CALIFORNIA COASTAL COMMISSION

STAFF RECOMMENDATION
ON CONSISTENCY DETERMINATION

Consistency Determination No.	CD-25-01
Staff:	MPD-SF
File Date:	3/14/2001
60th Day:	5/13/2001
75th Day:	5/28/2001
Commission Meeting:	5/9/2001

Construction of 100 ft. high steel communications tower to support combat system testing and training (Exhibit 4)

Figure 5. CEC RADHAZ AREA (Elevation view)

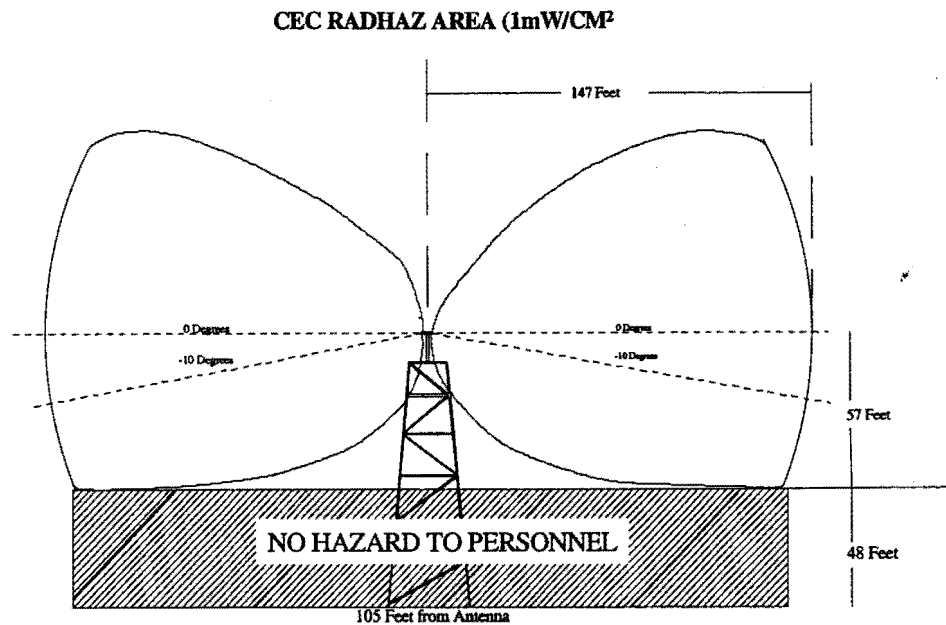
The Navy examined the potential for radar hazards in publicly accessible areas in its consistency determination. The Navy analyzed the facility under both Department of Defense radar standards, as well as the more stringent FCC guidelines. This analysis concludes that the only areas of concern would be within a radius of 147 ft. from the site, and no lower than 48 ft. above ground level (Exhibit 5-6). The Navy's consistency determination states:

The worst case Permissible Exposure Level (PEL) at 1 mW/cm² [megawatt/square centimeter] [i.e., the FCC guideline] distance with the CEC antenna operating at high power is 147 ft. from the antenna along the main-beam. Since the CEC antenna on the tower would be at least 105 ft. above ground level and no more than a -5 degree depression of the beam will be allowed, the PEL cannot be exceeded on the ground at any point where the public would be allowed access.

EXHIBIT NO.	6
APPLICATION NO.	
	CD-25-01

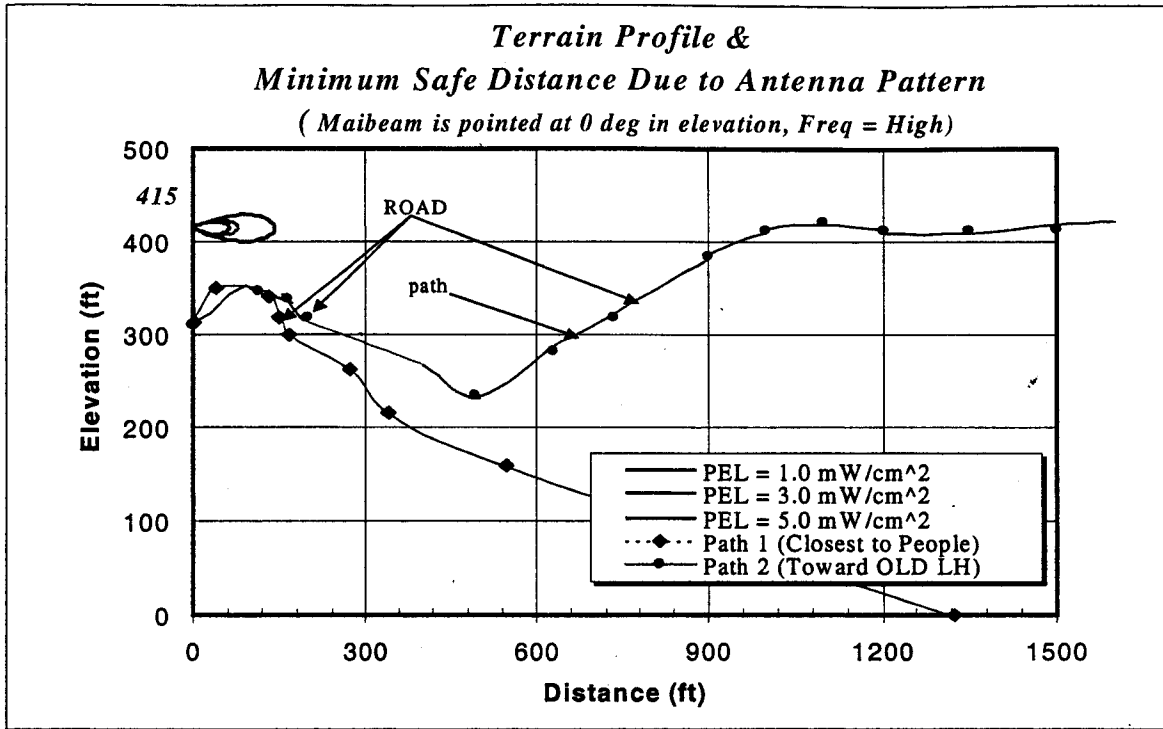
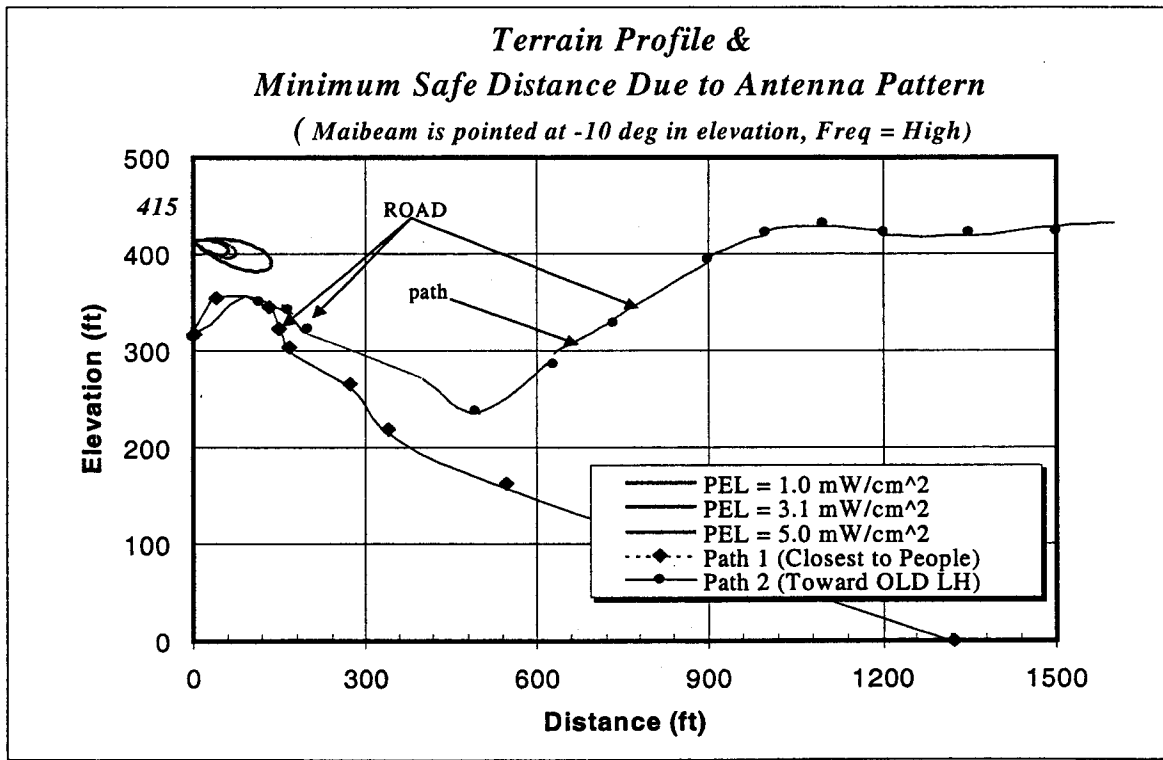
The nearest publicly accessible area would be 144 ft. from the tower; any closer would be off limits to the public. The signal strength at this point would be 0.7 mW/cm², which the Navy states is "well within the FCC guidelines." The Navy also points out that:

Finally, even though the publicly accessible area at the lighthouse is at a higher ground level elevation, the lighthouse is too far from the tower to receive hazardous exposures (see Exhibit 6). The Commission agrees with the Navy's analysis and finds that the public would not be exposed to hazardous RF radiation levels, and the Commission therefore concludes that the proposed project is consistent with the public access and recreation policies (Sections 30210-30214 and 30221) of the Coastal Act.

EXHIBIT NO.	7
APPLICATION NO.	
	CD-25-01

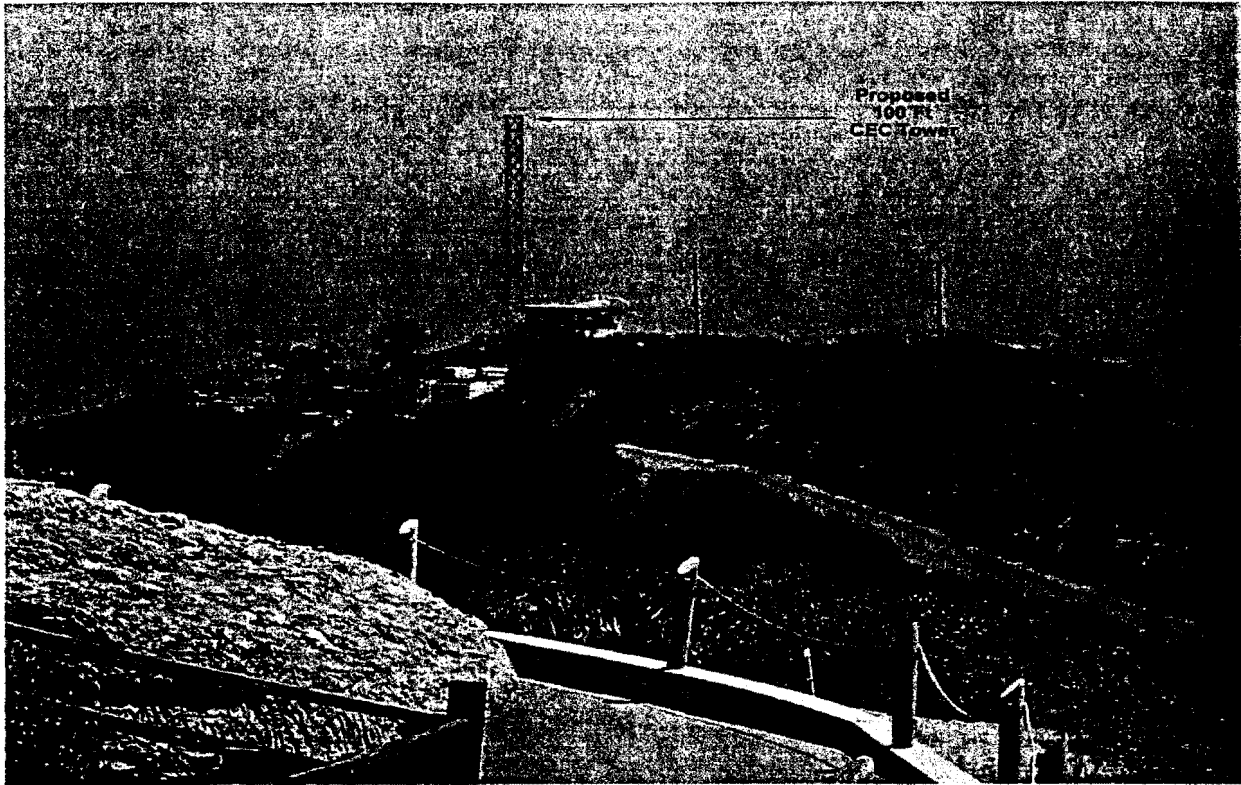
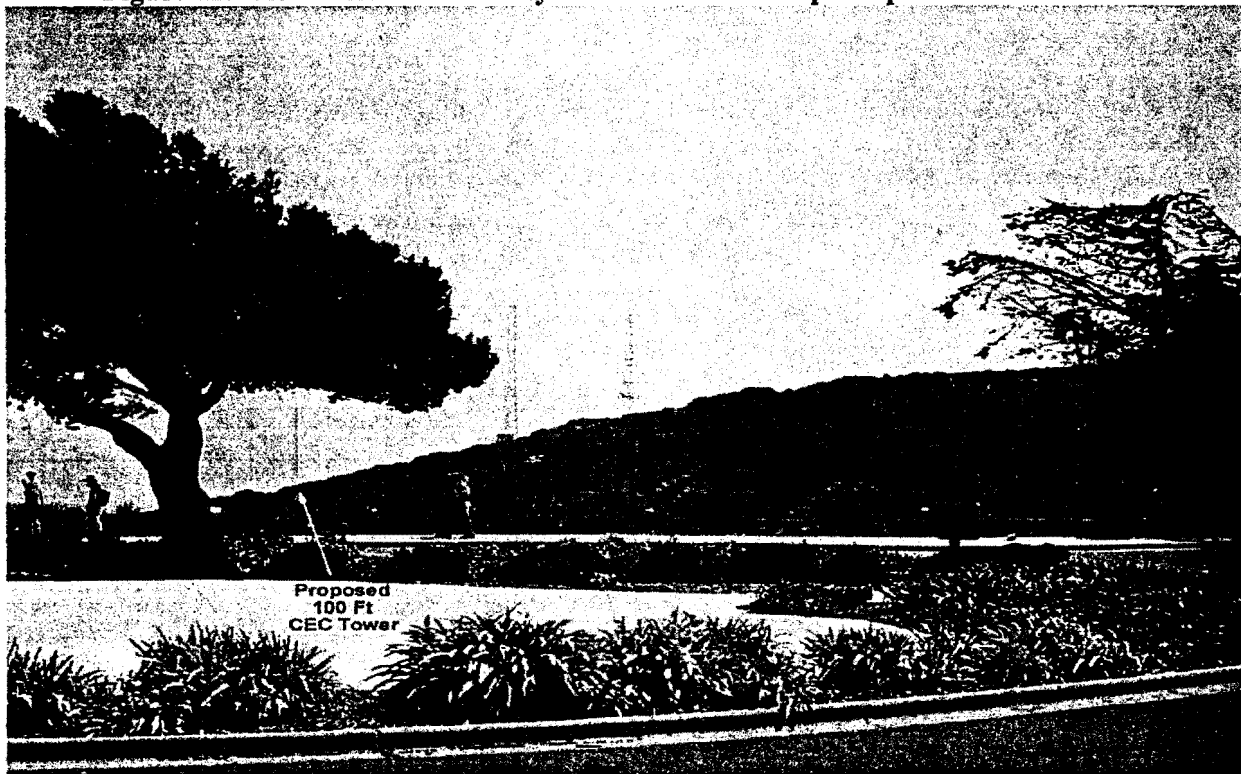
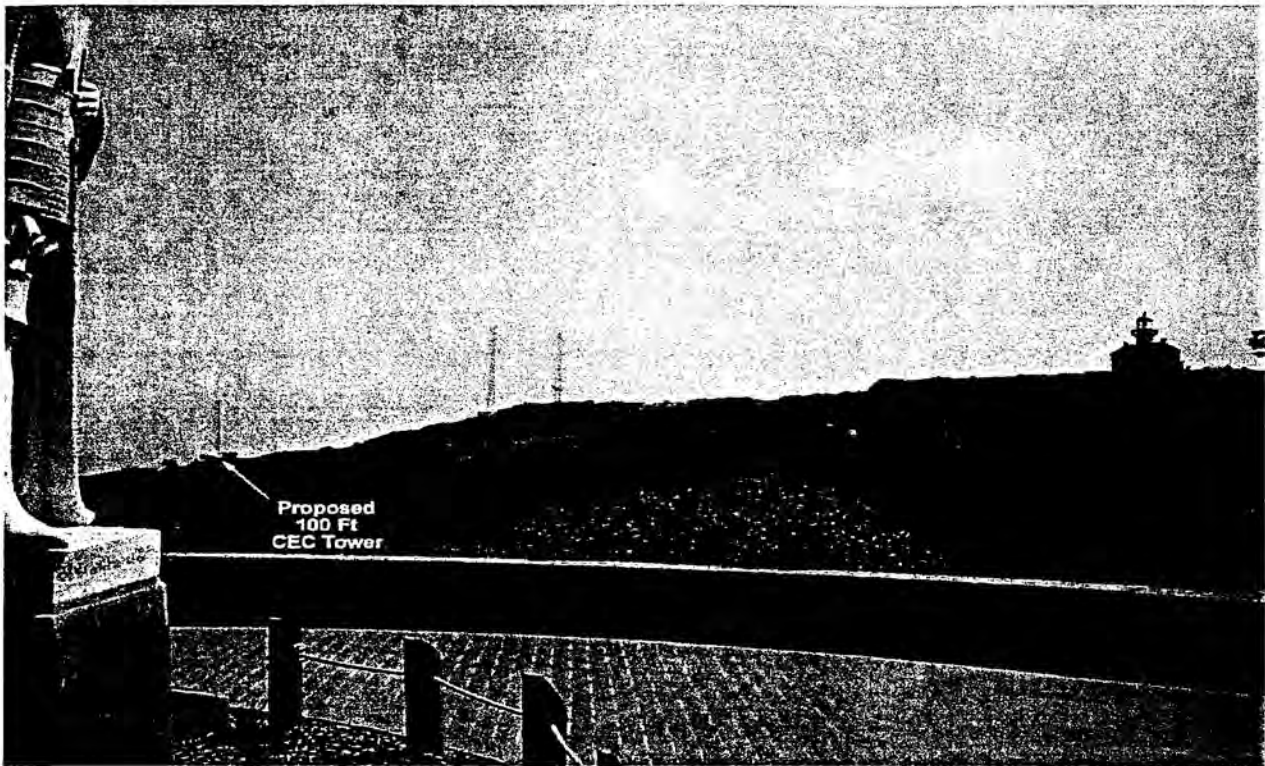
The Navy has minimized the visual impact of the proposed action on the coastal area (see ... [Exhibits 7-10]). The overall incremental visual impact from the tower would be minimal because there are two other prominent antenna towers in the area. The Navy's mission requirements for connectivity to other systems mandate a coastal location for the tower. The tower will be sited on a Navy installation that already has existing towers and is thus, compatible with the character of that site. The Navy has carefully reviewed the location, placement and height of the tower to enable it to meet mission requirements while minimizing impact to coastal resources. The Navy has balanced potential visual impact of the tower, to the maximum extent practicable, with the potential impacts of radiation hazard associated with the elevation and height of the tower. The height of the tower was selected not only to ensure mission requirements of connectivity to other systems but to minimize the potential impact to the public from radiation hazards (real or perceived). There are two existing towers closer to the Cabrillo Monument that would be more prominent when viewed from the park area. The primary viewing areas from the monument grounds are toward the lighthouse, the ocean (whale watching) and towards the islands off shore. The tower at Battery Humphrey would be visible but would not be in the main line of sight for those areas. The impact of the towers visually has been balanced, to the maximum extent possible, with the impact that would result from the radiation hazard that would exist if the antennas were installed at a lower elevation. ... Also ... [Exhibits 3 & 7-10] show that the existing towers provide much more of an impact than the proposed tower and that offshore viewing would not be significantly impacted.

The hundred foot CEC tower will intrude upon the natural and historical scene from at least some viewing areas at Cabrillo NM, in particular the statue of Juan Rodríguez Cabrillo.

...[A]lthough a new hundred-foot tower is not desirable, the fact that it will be only partly visible from viewpoints in the park makes it acceptable. The removal of the existing red and white tower south of the Old Point Loma Lighthouse will help compensate for the construction of the new tower, while enhancing the scenic values of the park and we strongly support the Navy in this effort. We are pleased that the Navy is also integrating design features in the CEC tower that will help reduce or eliminate it as a hazardous perch for birds of prey. This cooperative effort indicates to us the Navy's interest in preserving the resources of the area as much as feasible, given the nature of the project.

Cabrillo NM is a popular destination for many local and out-of-town visitors with over one million people visiting annually. The primary reason visitors come to the park is to enjoy the view of San Diego, Mexico and the Pacific Ocean. In keeping with the park's mission, the National Park Service is working to restore the native natural habitat and recreate a sense of how the area might have appeared during the time the Old Point Loma Lighthouse was in operation during the 1880s. The hundred-foot CEC tower will intrude upon the natural and historical scene from at least some viewing areas at Cabrillo NM, in particular the statue of Juan Rodríguez Cabrillo.

We understand the Navy's strong need for and commitment to the CEC program, and although a new hundred-foot tower is not desirable, the fact that it will be only partly visible from viewpoints in the park makes it acceptable. The removal of the existing red

Thus, the Navy has selected the least visually damaging feasible site and agreed to make good faith efforts to relocate facilities and possibly remove the existing tower. The Commission finds that the project complies with the requirements of Section 30251 to minimize scenic coastal view impacts and be visually compatible with the character of the surrounding area. The Commission further finds that, to the extent feasible, the Navy has been willing to pursue additional efforts to remove the existing, more visually damaging tower and restore and enhance visual quality in a visually degraded area. The Commission therefore concludes that the project is consistent with the requirements of the view protection policy (Section 30251) of the Coastal Act.
